Joint Regional Planning Panel (Sydney East Region)

JRPP No.	2013SYE051
DA No.:	DA/320/2013 – Demolition of the existing buildings; excavation works and construction of a part 6, part 7 mixed use development comprising ground level retail space, 100 residential units and 3 basement levels of 277 car spaces and associated landscaping works at 84-108 Anzac Parade
Applicant:	Luxcon Group
Report By:	Scott Williamson, Senior Assessment Officer.

Figure 2: Montage of the amended proposal

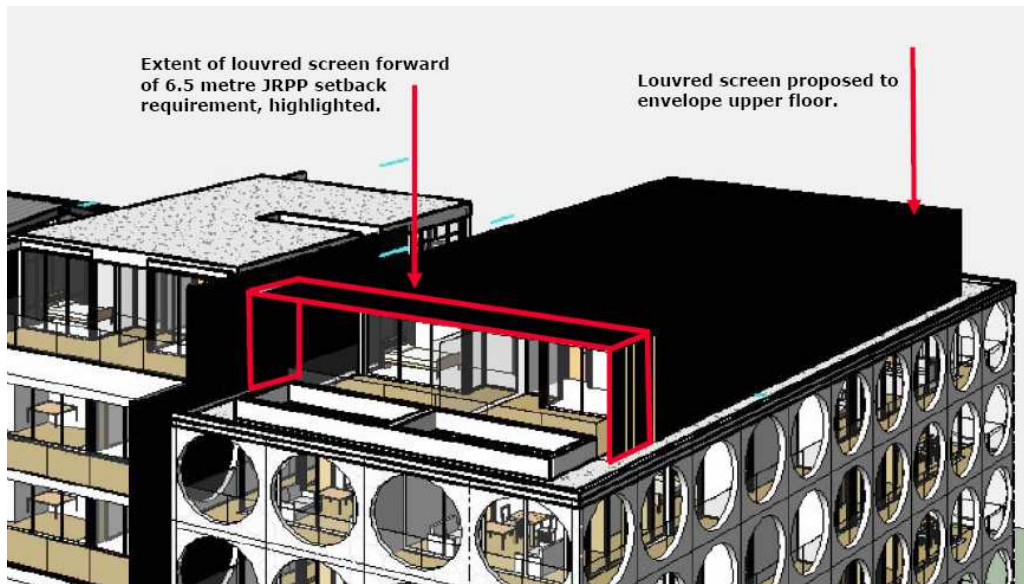
The plans submitted on 14 March 2014 show the above required changes having been largely implemented. The bulk of level ten (10) on the southern corner element of the building has also been redistributed, generally sitting within the identified setback constraints.

The height of the metal screen has been reduced, no longer enclosing level ten (10). It should be noted the upper floor has now been wrapped in an alternative screening treatment.

The new screening will present external bulk to level ten (10) that protrudes forward of the required 6.5 metre front setback. In this respect the design does not meet the

required 6.5 metre Anzac Parade setback. It is recommended a condition of consent require reduction in the extent of this screening component to be consistent with the 6.5 metre setback requirement.
